SuperShooter III WARNING BULLETIN

For those customers using the BLU-JET SuperShooter III mounting bracket with the FLO-MAX Safety Coupler, please be advised that a Hydrostat or a Bleed Valve, if installed in the wrong location, will interfere with the bracket during a disconnect.

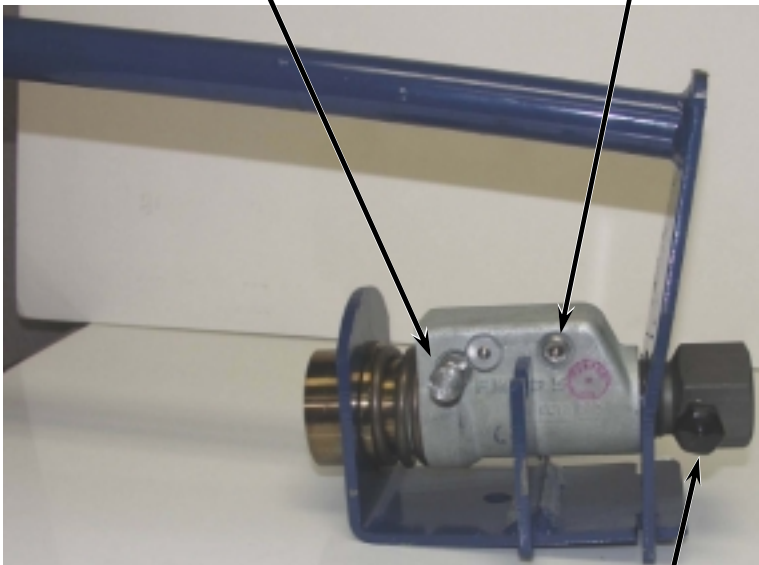
The Body of the FLO-Max will move approximately 1/4" toward the Spring during disconnect or reconnect, and this movement is the reason for the interference problem.

A 1/4" NPT Bleed Valve must be installed at this location **ONLY**.

Install a 1/4" NPT Socket Head Pipe Plug, flush with the Coupler Body, in this location.

To mount a Hydrostat with this arrangement, install a Squibb-Taylor 2032-5000, 1-1/4" Adapter at the outlet of the FLO-MAX.

When installing a Hydrostat with a Bleed Plug, use a Nipple & Tee, as shown.

WARNING:
DO NOT USE THIS ARRANGEMENT WITH PGI/PIONEER STANDARD BRACKETS.
